UNITED STATES PATENT AND TRADEMARK OFFICE

Office Action Summary	Application No.	Applicant(s)
	10/553,056	CHUNG ET AL.
	Examiner	Art Unit DNYANESH KASTURE 3746

DETAILED ACTION

Figure 2A
of Song

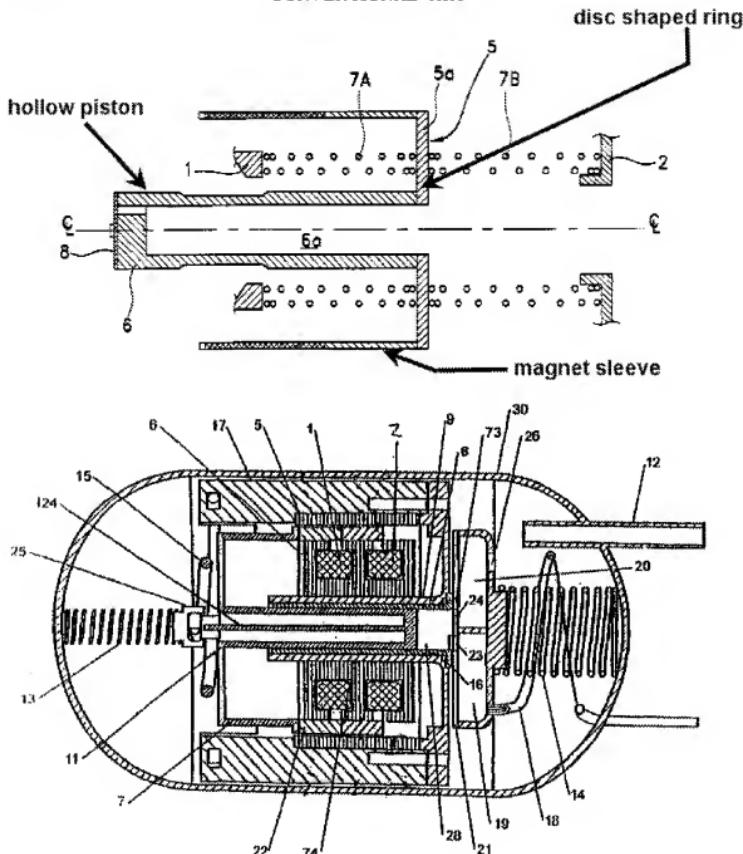
6. In Re claim 1, with reference to Figure 2A depicted above, Song discloses a piston assembly (Column 1, Line 35) comprising:

- a hollow cylinder shaped magnet sleeve (annotated) having a magnet (at the bottom of the magnet sleeve – part of "magnet assembly 5")
- a hollow cylinder shaped piston (annotated), inserted into a hollow space of the magnet sleeve as depicted
- a hollow disc shaped ring (5a) fixed to the piston
- the magnet sleeve and piston are coupled together as they are integrated with the hollow disc shaped ring
- wherein an edge side circumferential surface of the magnet sleeve and an inner peripheral surface of the ring contact each other, since the vertical section (sleeve) is

separate from the horizontal section (ring) as denoted by the conventional cross section lines (see region of contact)

7. However, Song does not explicitly disclose that the magnet is bonded on the external circumferential surface, and that the disc is fixed to the piston by shrink fitting process, and welded to the magnetic sleeve which is made of the same material as the ring.

Figure 2 of Choi et al

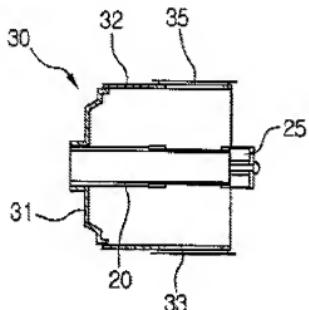
11. Nevertheless, with reference to Figure 2 depicted above, Choi et al discloses a piston assembly (Paragraph [0026]) comprising:

- a hollow cylinder shaped magnet sleeve (32) having a magnet (33) bonded together by magnet cover (35) on the external circumferential surface
- a hollow cylinder shaped piston (20), inserted into a hollow space of the magnet sleeve as depicted
- a hollow disc shaped ring (31) fixed to the piston (20) by welding process, and fixed to magnet sleeve (32) also by welding process. Paragraph [0013], Lines 4-6 state: "For example, the piston 20 and linking member 31 are welded together, as are the linking member 31 and the magnet holder 32". The magnet sleeve and piston are therefore coupled to each other.

12. However, Choi et al does not disclose that a shrink fitting process is used to fix the piston to the ring. Nevertheless, Choi et al discloses that there are other methods for forceful coupling between parts as stated in column 2, line 1: "forceful coupling methods, such as force fit, welding, etc., to secure the parts together". In accordance with MPEP 2113, the method of forming a device is not germane to the issue of patentability of the device itself. In this case, the claim is to a piston assembly which is a device/apparatus, and the method of forming the piston assembly including the technique used to fix the piston to the ring is not germane to the issue of patentability of

17. In Re claim 7, with reference to Figure 2, Choi et al discloses a piston assembly (Paragraph [0026]) comprising:

- a hollow cylinder shaped magnet sleeve (32) and a magnet (33) bonded together by magnet cover (35) on the external circumferential surface
- a hollow cylinder shaped piston (20), insertedly equipped in the hollow space of the magnet sleeve as depicted

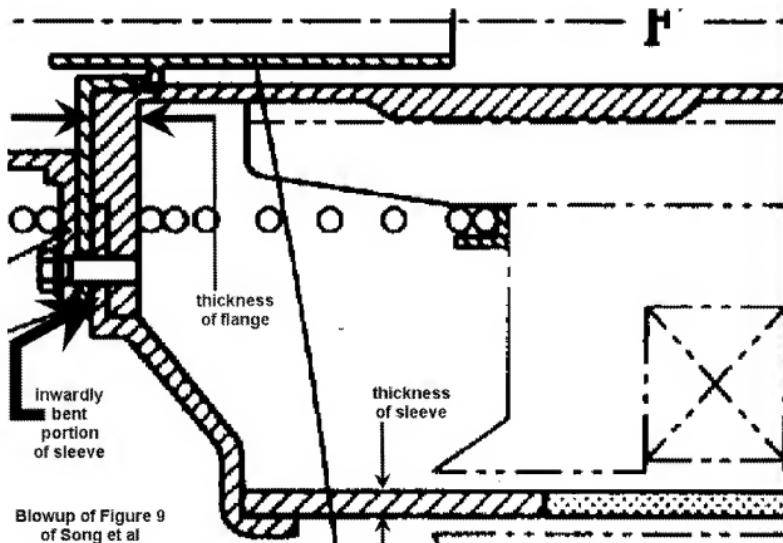
19. Nevertheless, with reference to blowup of Figure 9 depicted above, Song et al discloses a sleeve (7, 8) having an inwardly bent portion as depicted at one end of a hollow space thereof, a flange as depicted having a thickness that is greater than the thickness of the sleeve (see annotations), a fixing member inserting hole formed in the flange in the region of the inwardly bent portion of the sleeve, and a fixing member which appears to be a bolt/screw.

35. In Re claim 11, Choi et al and Song et al as applied to claim 7 discloses all the claimed limitations including the bent portion also having a fixing member inserting hole as depicted by Song et al because the bolt passes through both the flange and the bent portion in order to secure the two together (the bolt can be seen in the blow up depicted

above of Figure 9 of Song et al in the region of the bent portion), except that Choi et al and Song et al do not disclose that the fixing member is fusion fixed to the magnet sleeve by an applied electric current and functioning as a filler metal to fix the bent portion and the flange together.
